SUBJECT: R.E. Ginna Nuclear Power Plant
Docket No. 50-244

Response to Requests for Additional Information Regarding Topics Described in Meeting Minutes

**RESPONSES TO NRC MEETING MINUTES FROM SEPTEMBER 15, 2005 MEETING
(See NRC letter dated 10/24/2005)**

Figure 2.8.5.0-6
Integrated DPC Used in Non-LOCA Transient Analyses

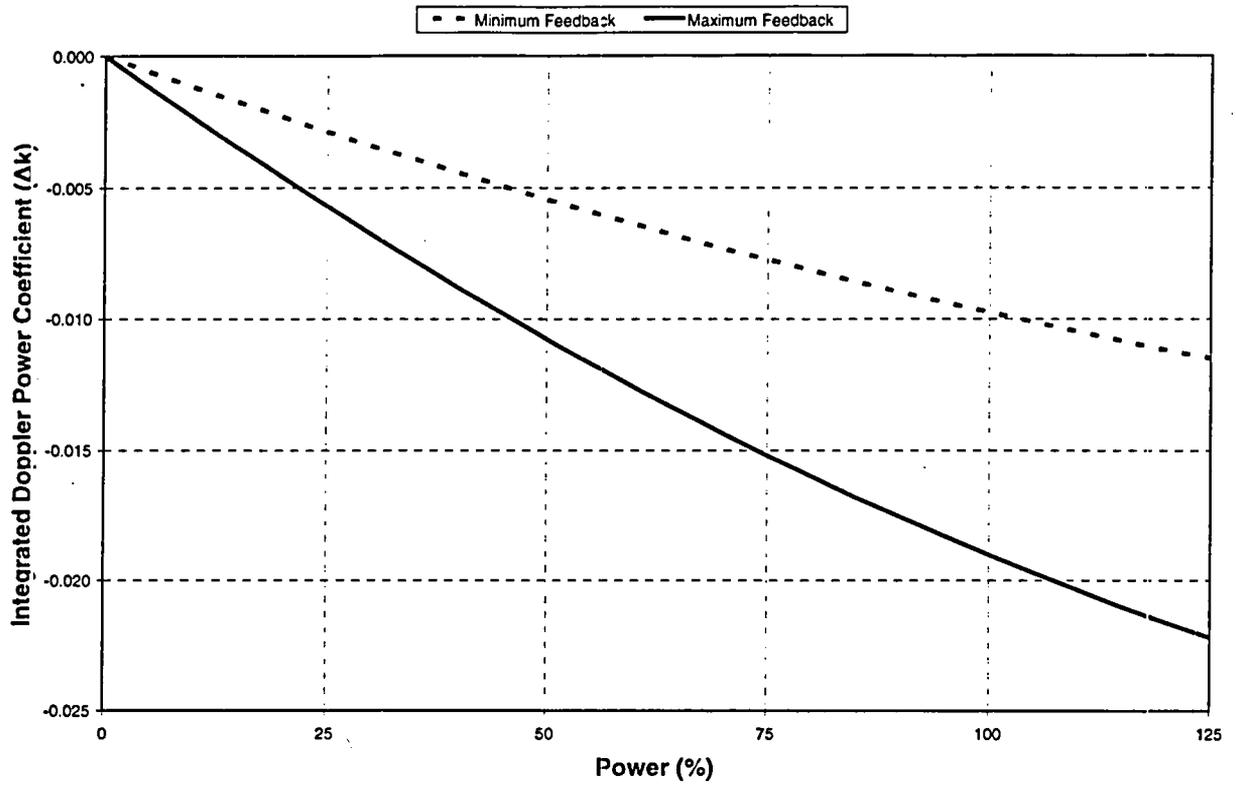
Assumptions and other initial plant conditions used in each non-LOCA transient analysis.

Table 2.8.5.0-6 and Figure 2.8.5.0-6 contain reactivity feedback assumptions.

Figure 2 – Hot Rod Peak Cladding Temperature

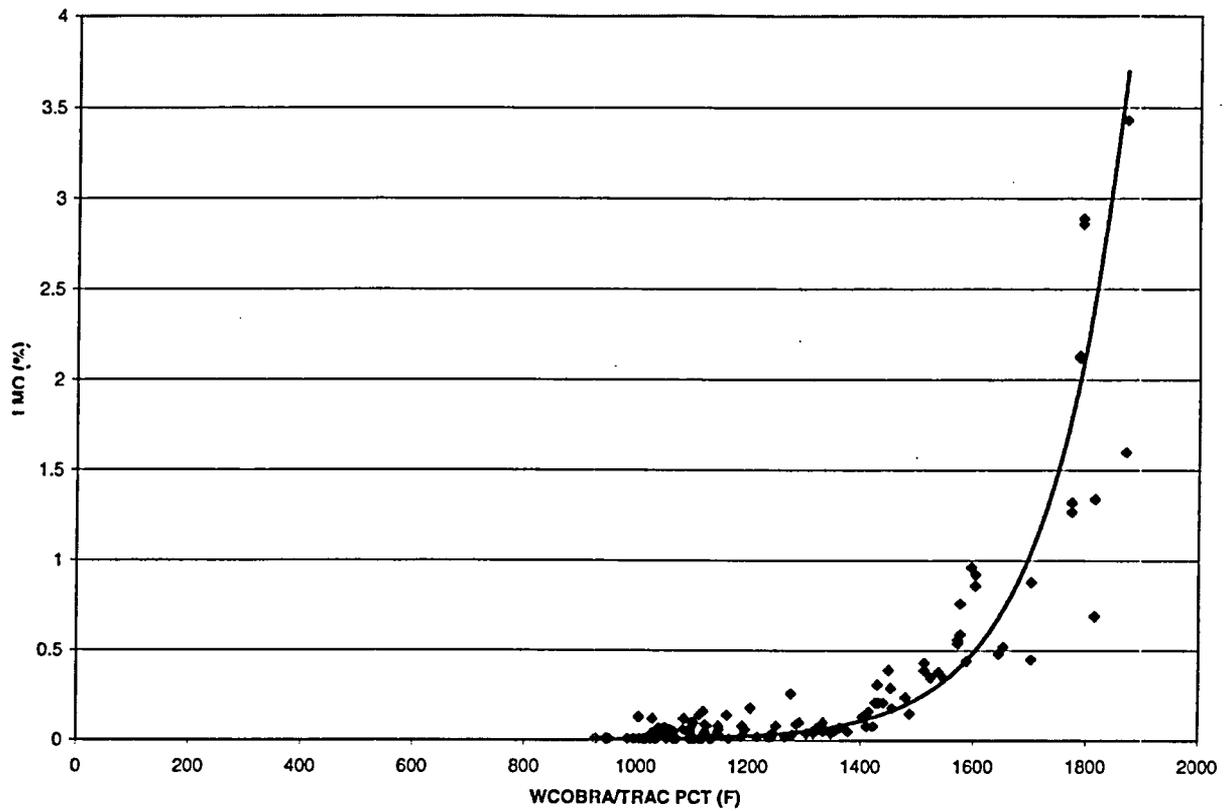
Provide the Peak Clad Temperature (PCT) and Local Maximum Oxidation (LMO) results for the already burned, resident OFA fuel at EPU conditions for Ginna. Specific quantified results should be provided, as well as a brief summary of the methodology used to determine these values.

Figure 2 shows the PCT transients for a full core of 422V+ fuel compared to a transition core with mixed fuel. Figure 3 compares the hot assembly collapsed liquid level between the two cases. It can be seen that the fuel design has little effect on the re-flooding behavior of the hot assembly.
